ANSONIA PARK AND RIVERWALK, SEGMENTS 3 & 4
CITY OF ANSONIA, CONNECTICUT
Conn D.O.T. PROJECT NO. 002-128
FEDERAL AID PROJECT NO. CN: PEDS (214)

ADDENDUM NO. 2

NOVEMBER 23, 2020

DESCRIPTION OF ADDENDUM

TOWN SEAL PLAQUE SHALL BE 30" IN DIAMETER

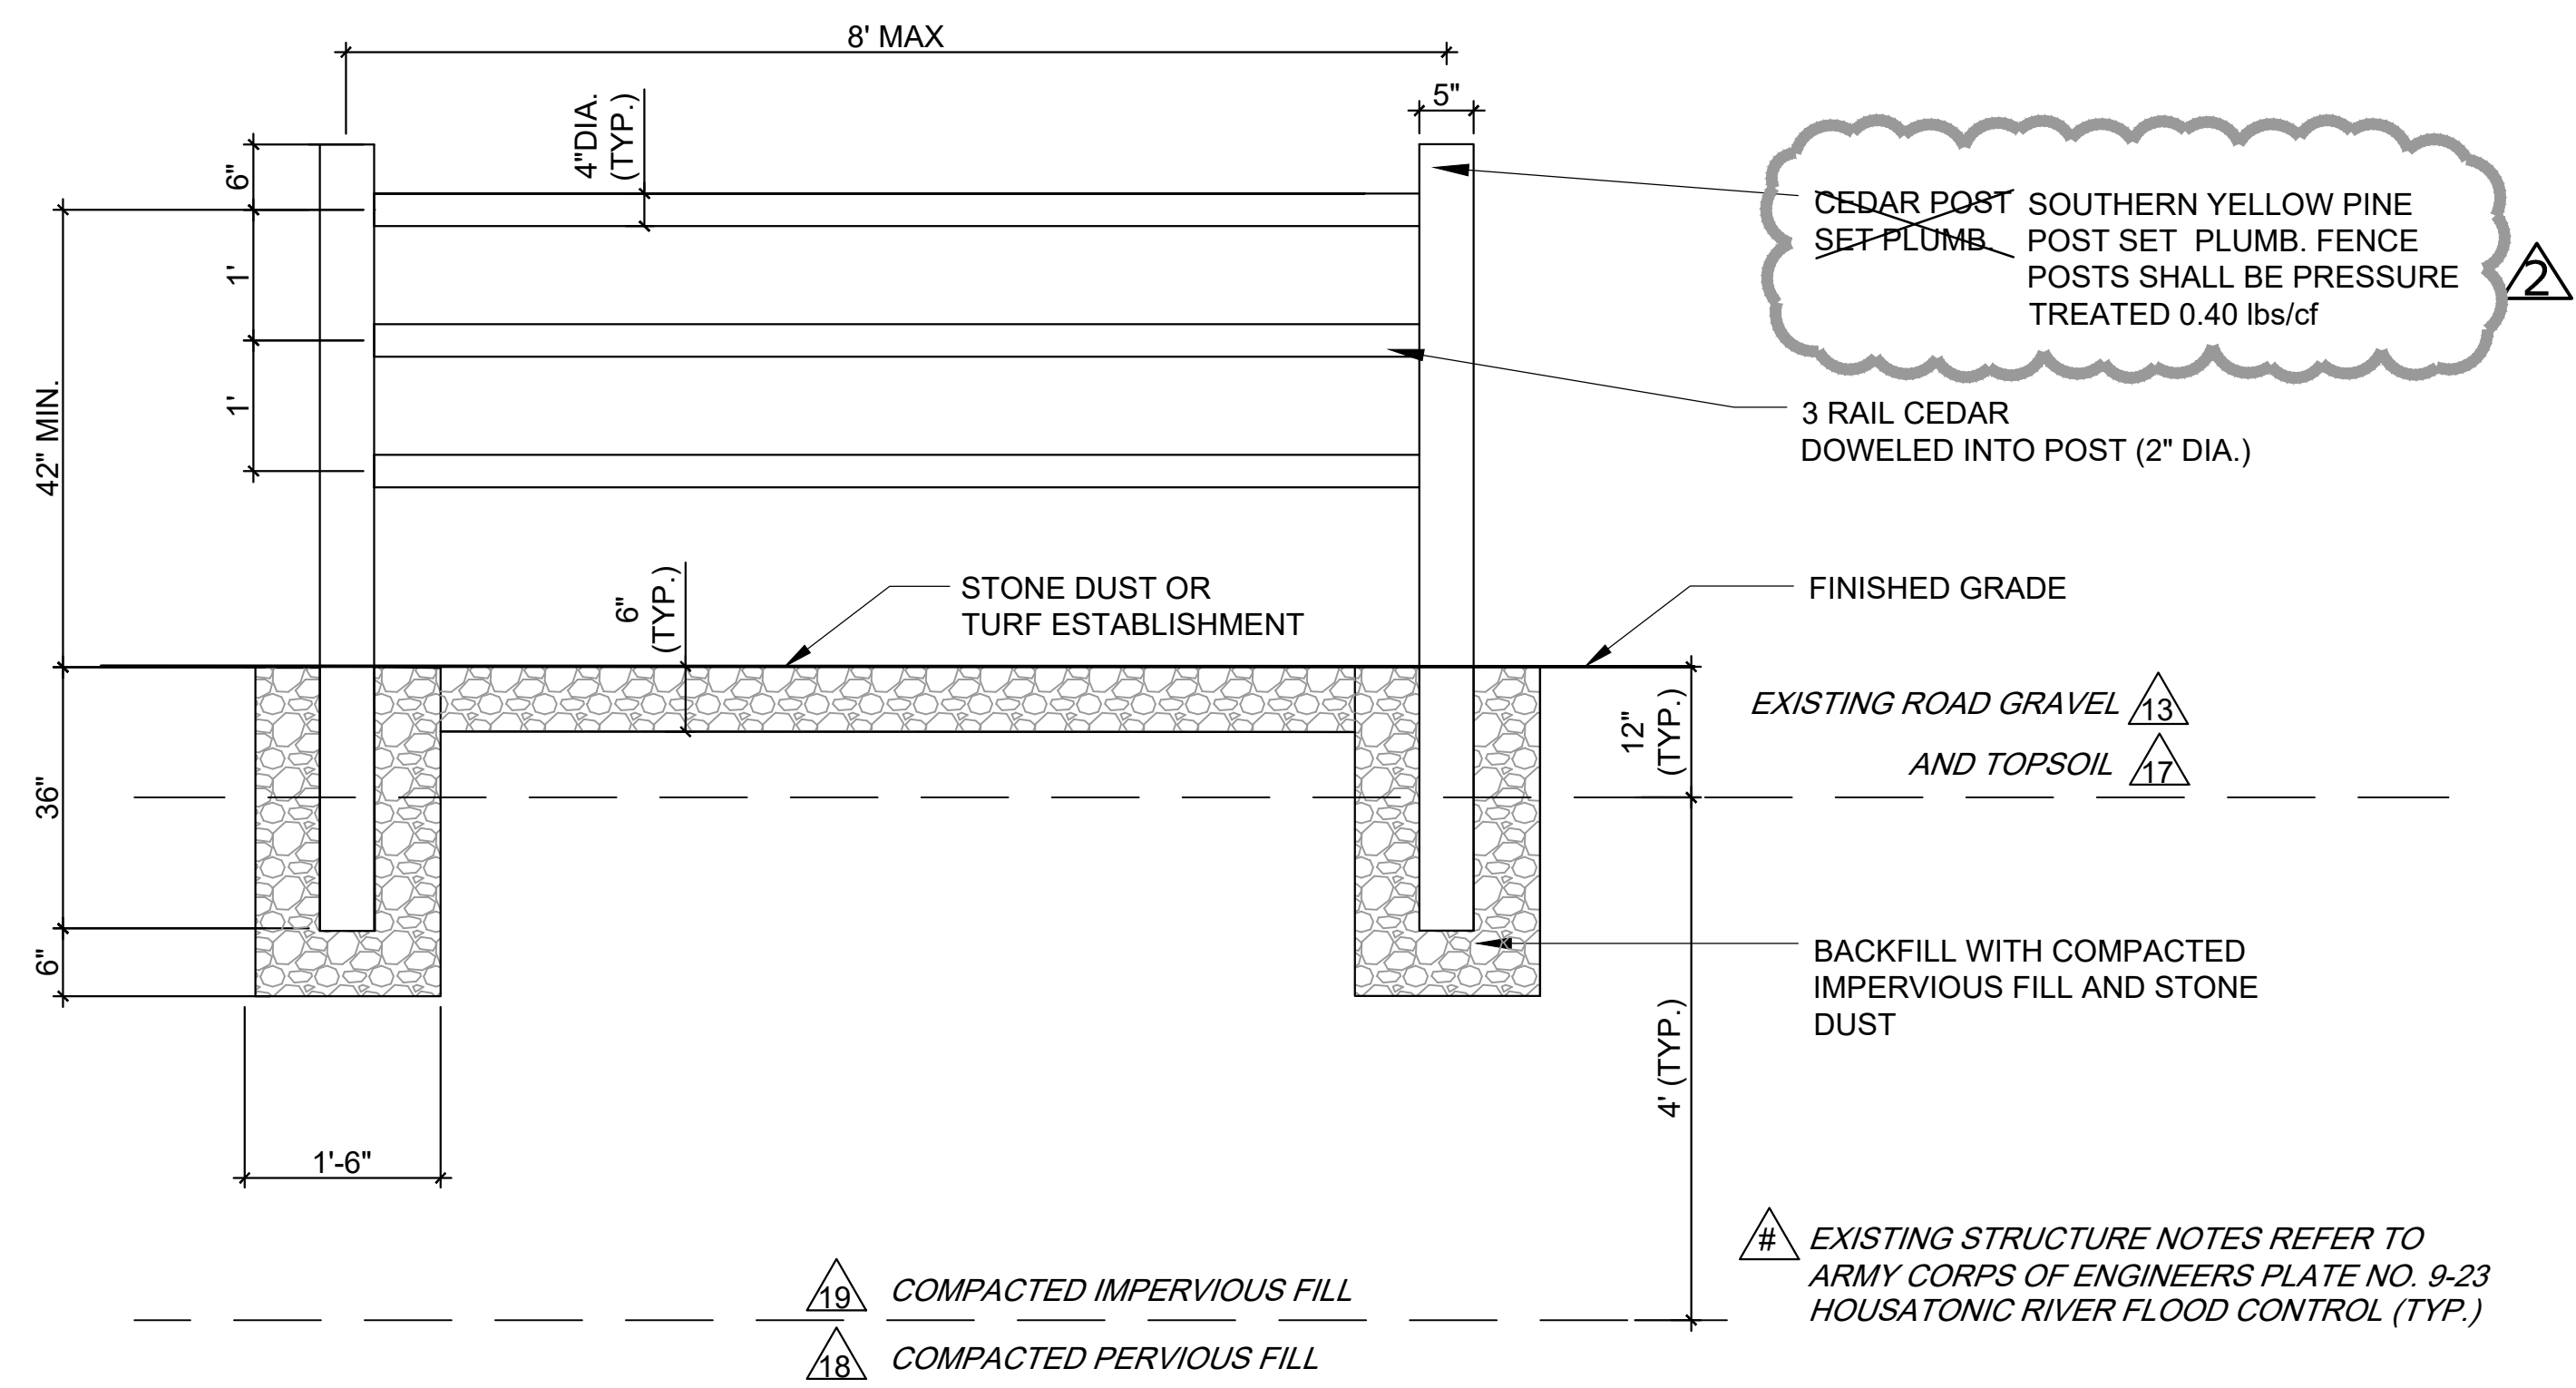
Question 2: Please provide a plan detail for the ornamental medallions as this is not in the plans and specifications.

Question 8: Please provide size and installation details of the flush Bronze plaque and historical town seal?

Response: **Ornamental medallions shall conform to the special provision for Item #0992132A – Ornamental Medallion. The circular plaque shall be 30" in diameter and have the City of Ansonia seal, see attached details. The rectangular plaque shall be 36" by 36", see attached detail for the text. Both plaques shall be shallow (1/8") Bas-relief.**

SPLIT RAIL FENCE SECTION

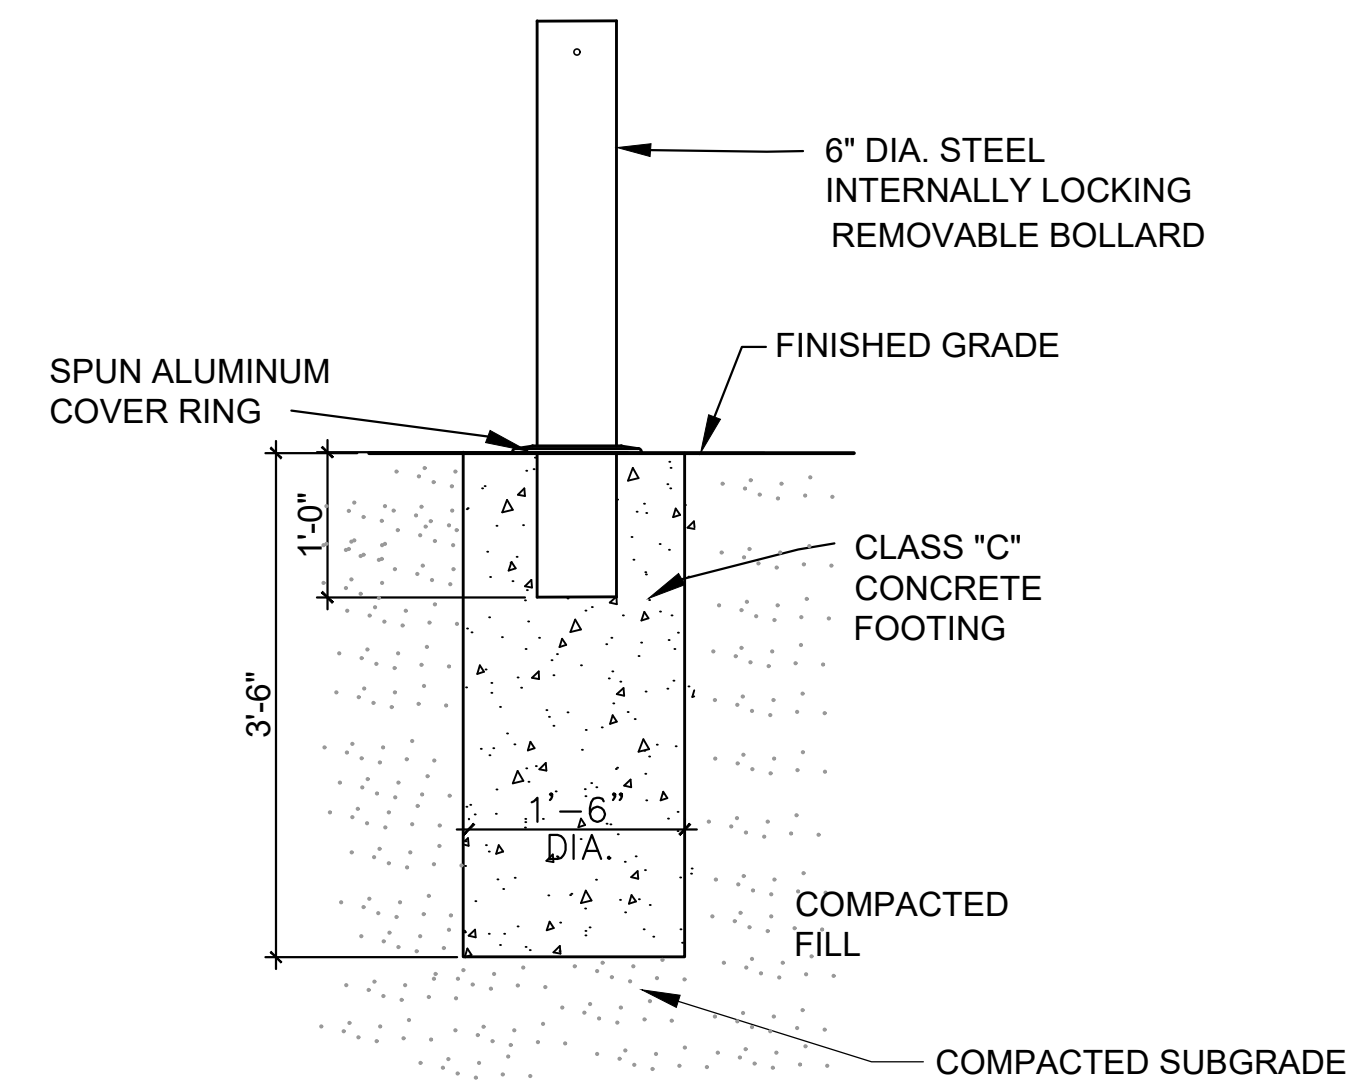
Question 5: We need clarification on item #0906203A Split Rail Fence; Special Provision Specification calls out Cedar Rails and Pressure Treated Posts and drawing No L-3 details cedar posts and rails. Please clarify if they want the fence in all pressure treated or all cedar.

Response: **The Split Rail fence shall have Cedar Rails and Southern Yellow Pine posts with a 0.40 lbs/cf pressure treating for ground contact.**

48"x48" COMPASS ROSE NARROW DETAIL

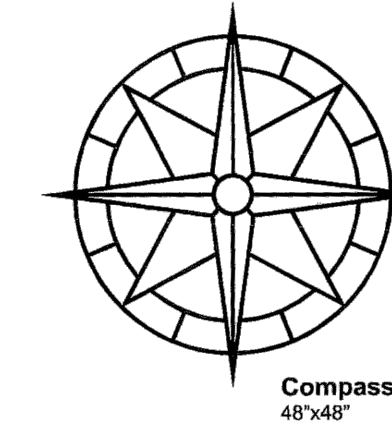
Question 7: Please confirm the compass rose is a concrete stamp? Please confirm, coloring or staining is not required of the concrete if it is a stamp?

Response: **The compass rose shall be stamped concrete and shall be stained in an antiqued style.**

NOTE:
THE COMPASS ROSE SHALL BE STAMPED CONCRETE,
IT SHALL BE STAINED IN AN ANTIQUED STYLE. THE
COMPASS ROSE WILL BE PAID FOR AS A LUMP
SUM UNDER ITEM #0601401A ORNAMENT MOLDS
